Subject: Dresden Nuclear Power Station Units 2 and 3
Quad Cities Nuclear Power Station Units 1 and 2
Response to Station Blackout Safety Evaluations
NRC Docket Nos. 50-237/249 and 50-254/265

Attachments: Figure 1 - Single Line Diagram for AAC Diesel Generators
(Dresden Station)

Figure 2 - Single Line Diagram for AAC Diesel Generators
(Quad Cities Station)

FIGURE 1

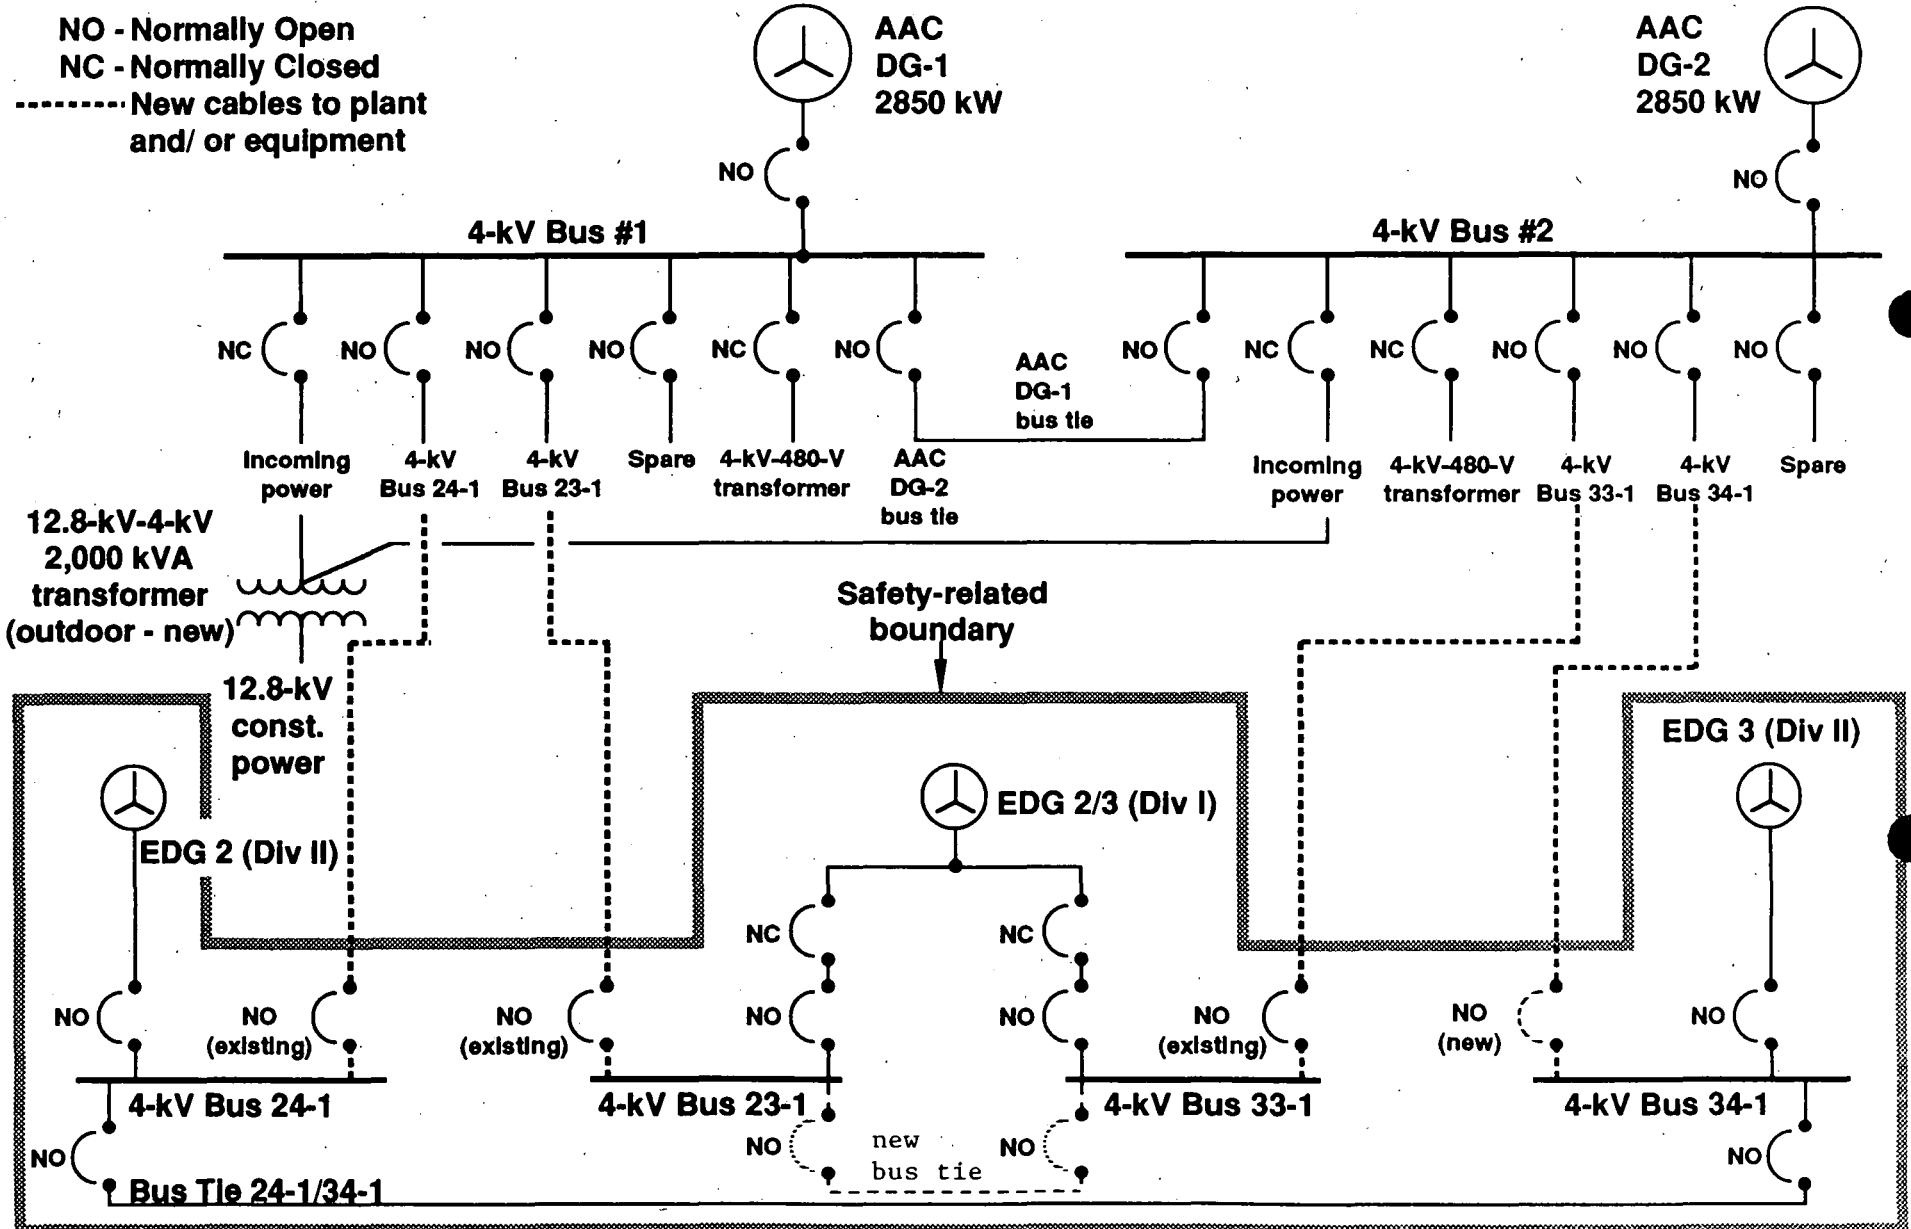
Preliminary engineering for the AAC power source indicates that it would be more advantageous to supply the generating capacity from two equally-sized diesel generators (instead of one), as shown on Figures 1 (Dresden) and 2 (Quad Cities). The AAC diesel generators will be installed in accordance with the criteria in Appendix B of NUMARC 87-00, and will have the capability to connect to all 4 kV safety buses (buses 23-1, 24-1, 33-1 and 34-1 at Dresden/buses 13-1, 14-1, 23-1 and 24-1 at Quad Cities). By maintaining the AAC power source capacity, and the ability to connect to all four safety buses, the 0.95 target reliability for the emergency diesel generators should remain unchanged.

CECo believes utilizing two diesel generators for the AAC power source will provide an enhanced design which will preclude the total loss of the AAC power source should one of the diesel generators become unavailable. Additionally, there is a concern that a single AAC diesel generator will have the capacity of providing fault currents which may exceed the interrupting capability of the existing 4 kV safety buses.

As part of the AAC power source modification, cross-tie capability between safety buses 23-1 and 33-1 at Dresden Station, and between safety buses 13-1 and 23-1 at Quad Cities Station, was being provided (utilizing the AAC power source bus) to improve the "Independence of Off-Site Power" classification to "Group I 1/2". Sections 2.1 and 2.2.2 of the safety evaluations indicate that in order to credit this cross-connect as a safe shutdown bus transfer, the connections from the output breaker of the proposed AAC power source to the safety buses would have to be safety grade. Since submittal of Reference (c), CECO has determined that a safety grade cross-tie will be installed directly between the safety buses (as shown on Figures 1 and 2), instead of connecting through the AAC power source bus. This configuration will ensure that the cross-tie will be credited as a safe shutdown bus transfer.

It should also be noted that the AAC power source (diesel generators), and its associated buses, breakers and cabling, will not be installed safety-related (as shown on Figures 1 and 2); however, the isolation breaker at each safety bus will be safety grade.
